OFFICE OF INSPECTION AND ENFORCEMENT
DIVISION OF INSPECTION PROGRAMS

Report No.: 50-313/86-01

Facility Name: Arkansas Nuclear One, Unit 1

SCOPE: This special, announced team inspection involved 756 inspection hours to perform an in-depth assessment of the operational readiness of the emergency feedwater system.

FIGURE 1
 ANO-1 MAIN STEAM SUPPLY
 TO EMERGENCY FEEDWATER TURBINE PUMP

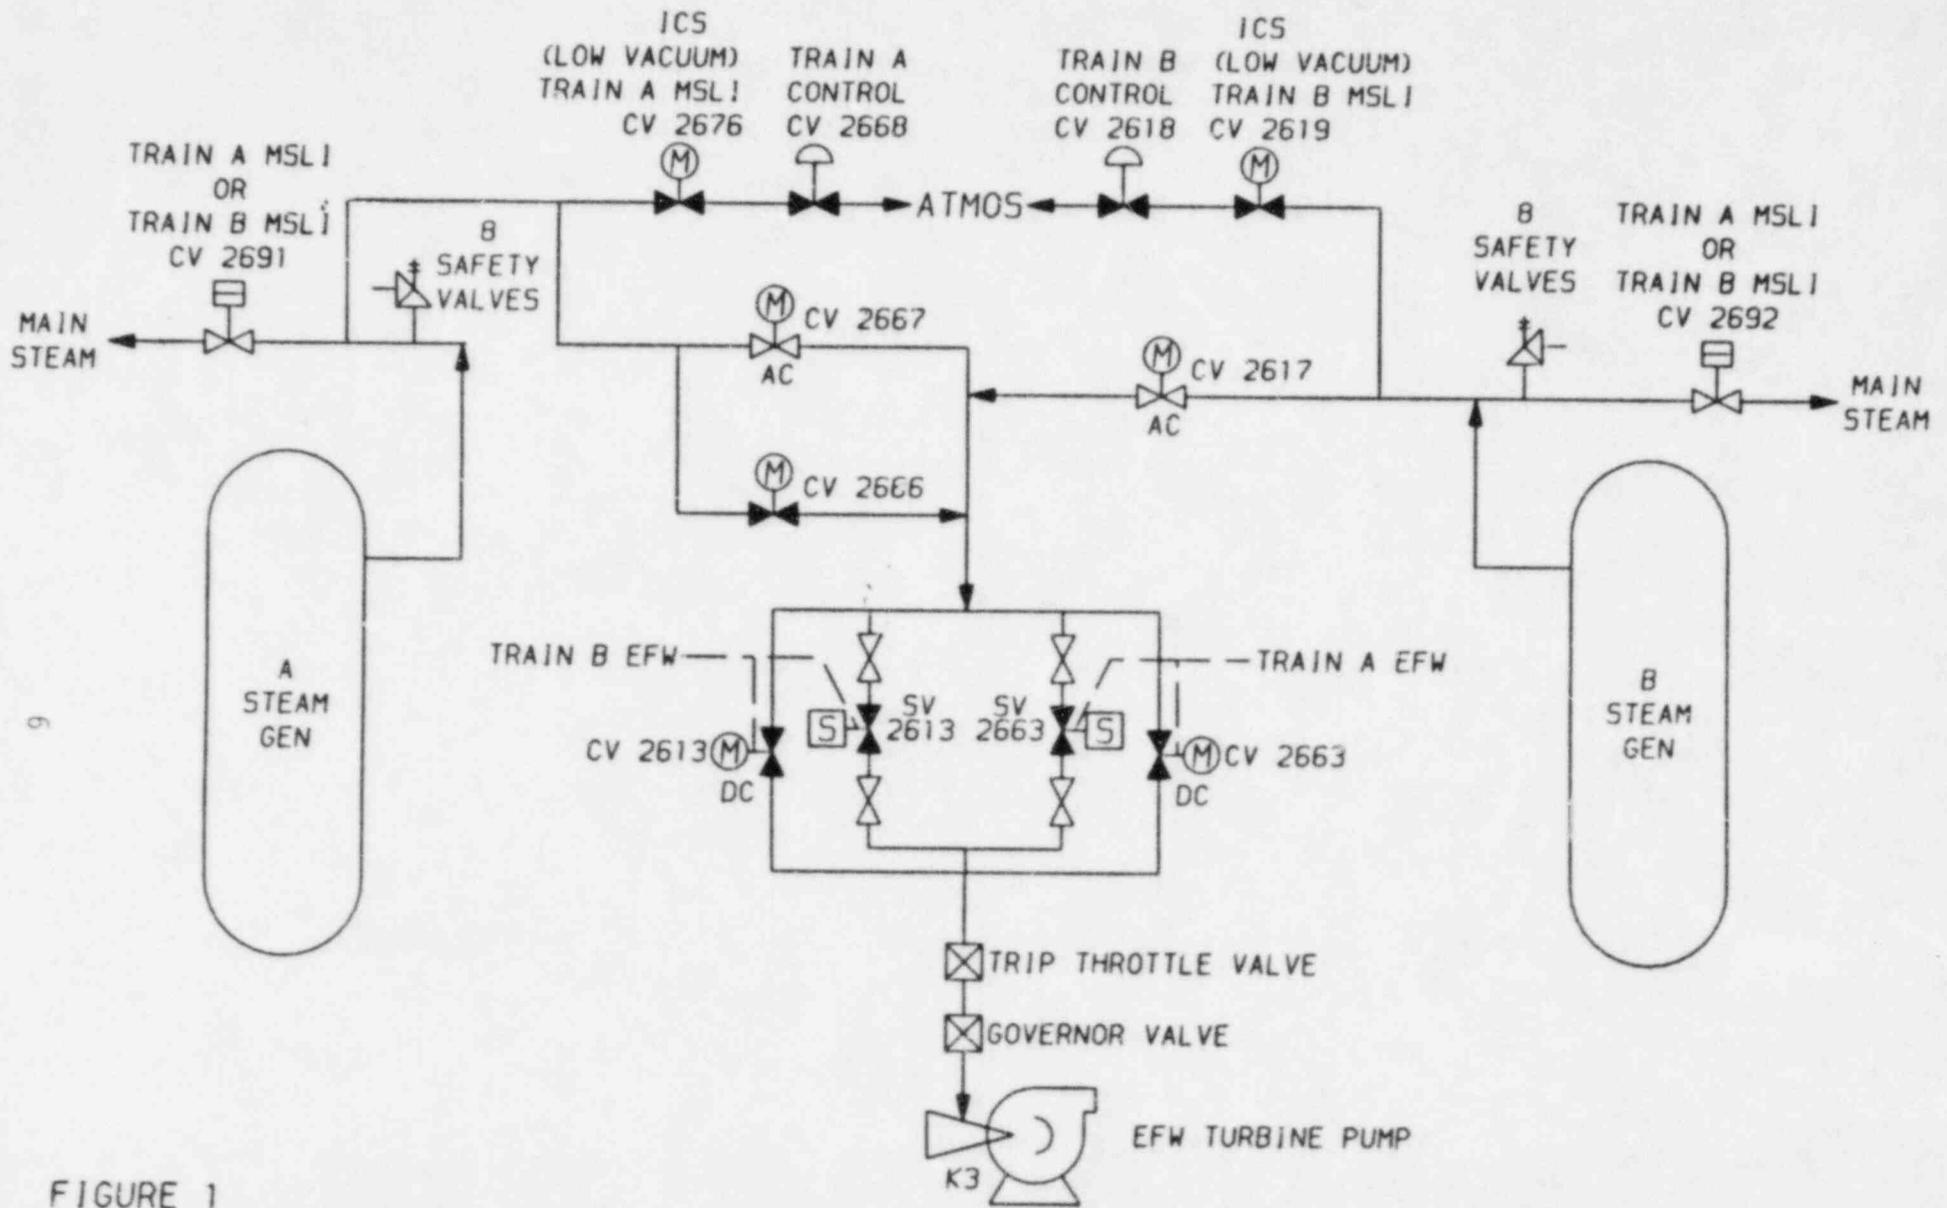
1. The inspection team identified design concerns regarding the ability of the EFW system to perform its safety function during abnormal events.
 - a. For steam line break accident scenarios, given a single active failure within the electrical power system (i.e., vital power), the emergency feedwater initiation and control (EFIC) subsystem did not have the capability to isolate the affected steam generator (SG) from the unaffected SG. It appeared that this could result in the loss of all EFW flow to both SGs. For a nonisolable steam line break in SG A with a concurrent loss of offsite power, the EFW system and EFIC subsystem rely on onsite power sources. If the loss of "red" ac power is assumed as the single active failure (i.e., failure of "red" diesel to start, fault on bus, etc.), the EFW motor-driven pump is unavailable and motive power is lost to operate CV-2667 (the isolation valve between SG A and the EFW turbine-driven pump). As a consequence, CV-2667 could not be closed and EFIC would have unsuccessfully attempted to isolate SG A from SG B. Instead, the unaffected SG B would have been cross-connected to the affected SG A through CV-2667 and CV-2617. As a consequence, both SGs could have depressurized through the nonisolable break, and the steam supply to the turbine-driven EFW pump may have been insufficient, causing a complete loss of EFW. In addition, the blowdown of two SGs through a nonisolable break inside the containment building was outside the design basis for the containment building (See figure 1, page 6).

Figure 1 on page 6 illustrates the main steam system supply configuration to the EFW turbine pump at the time of the inspection. The steam supply to EFW pump 7A is supplied from both SGs through normally open ac motor-operated control valves CV-2617 (SG B) and CV-2667 (SG A). Like the motor-driven pump, the EFW turbine pump supplies feedwater to either or both SGs depending on the EFIC vector signals. For a steam line break, the EFIC system will isolate the depressurized SG in order to isolate that affected SG from its associated main steam and main feedwater lines. If isolation of the affected SG does not isolate the break, the EFIC system will provide EFW only to the intact SG. For a nonisolable steam line break in SG A with a concurrent loss of offsite power, the EFW system relies on onsite power sources. If the loss of "red" ac power is assumed as the single active failure (i.e., failure of "red" emergency diesel to start, fault on bus, etc.), the EFW motor-driven pump is unavailable and motive power is lost to CV-2667. As a consequence, EFIC would have unsuccessfully attempted to close CV-2667, and therefore the unaffected SG B would have been cross-connected to the affected SG through CV-2667 and CV-2617. Both SGs would have then depressurized through the nonisolable break and the steam supply to the turbine-driven EFW pump could have been insufficient, causing a complete loss of EFW.

Review of DCP 82-1050 (the design change to install the new EFW turbine, new dc steam admission valves, and to modify EFW suction and discharge piping) indicated that a single-failure analysis was not performed. Specifically, question 15 of the DCP asked, "How was the impact of failure of the systems, components, and structures considered in the design?" In response, the Project Engineer indicated that the question was not applicable by answering "NA." This response was checked and approved without comment. Procedure 1032.01, "Design Control," Revision 7, required an independent reviewer to verify that responses to the Design Evaluation Questions had been properly addressed and that the discipline portion of the design change was complete and technically accurate.

Subsequent to the inspection, the licensee provided information indicating that, for the main steam line break accident postulated above, sufficient steam would have been available to the EFW turbine until SG pressure dropped to approximately 80 psia.

Subsequent to the inspection, the licensee provided information indicating that, for the main steam line break accident postulated above, sufficient steam would have been available to the EFW turbine until SG pressure dropped to approximately 80 psia.
